SAFETY EVALUATION

TURKEY POINT UNITS 3 AND 4

REACTOR SURVEILLANCE MATERIAL PROGRAM

PROPOSED CHANGE TO PLANT TECHNICAL SPECIFICATIONS

Arrangement of Surveillance Capsules in the Turkey Point Unit No. 3
Reactor Vessel (Lead Factors for the Capsules are Shown in Parentheses)

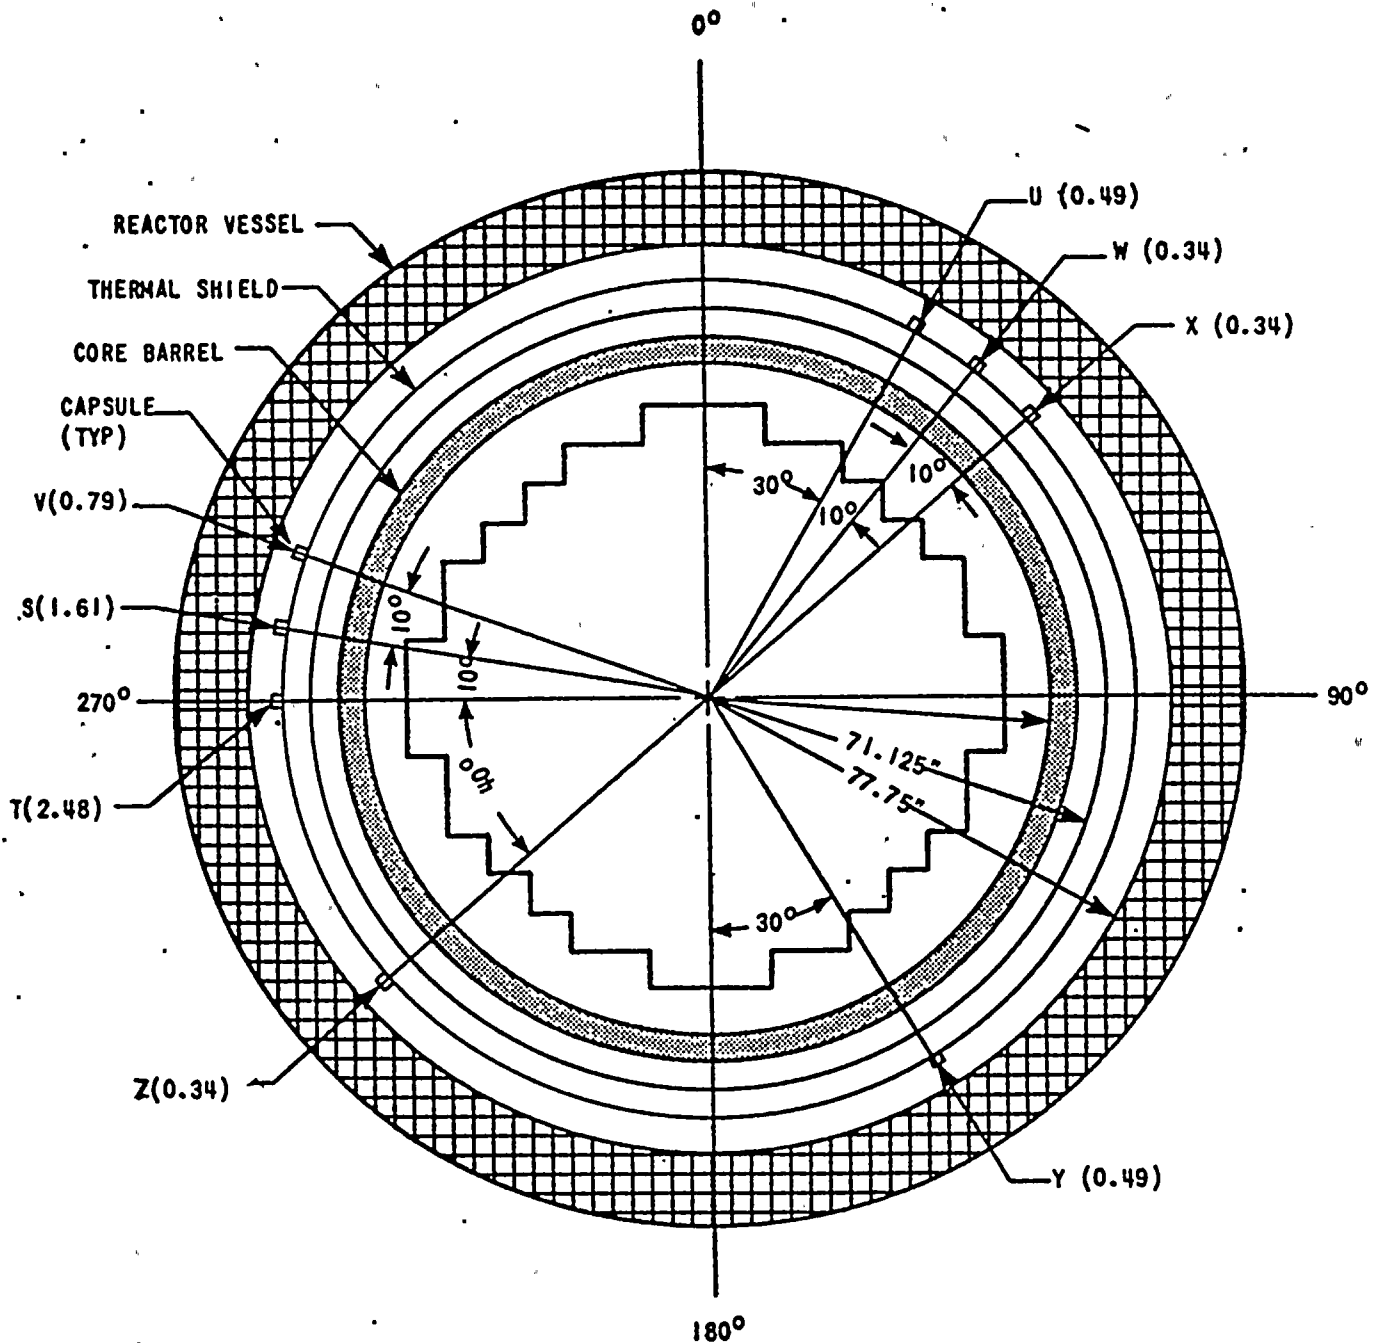
Attachment 1 is an excerpt from the PTP surveillance program. Attachment 2 shows the number and identification system of Type I and II capsules in each of the Turkey Point Vessels. As can be seen, there are only two Type II capsules remaining in each vessel. Attachment 3 shows the capsule locations.

To obtain the most meaningful results from the existing program and to update the program to current Appendix H requirements, FPL proposes to remove only Type II surveillance capsules for the remainder of plant life. This requires that 3 capsules be available for removal through the end of life. Since there are only 2 capsules available for each unit, we propose to integrate the surveillance programs as permitted by Appendix H, II, C.

Capsule 10	Unit	Removal Date	Wall Fluence (n/cm ²)	1/4T Fluence (n/cm ²)
T	PTP 3	Removed 1974		
T	PTP 4	Removed 1975		
S	PTP 3	Removed 1977		
S	PTP 4	Removed 1977		
V	PTP 3	12 years 1985	8.2×10^{18}	4.5×10^{18}
V	PTP 4	24 years	1.04×10^{19}	5.7×10^{18}
X	PTP 3	33 years	1.25×10^{19}	6.8×10^{18}
X	PTP 4	Standby		
U	PTP 3/4	Standby		
W	PTP 3/4	Standby		
Y	PTP 3/4	Standby		
Z	PTP 3/4	Standby
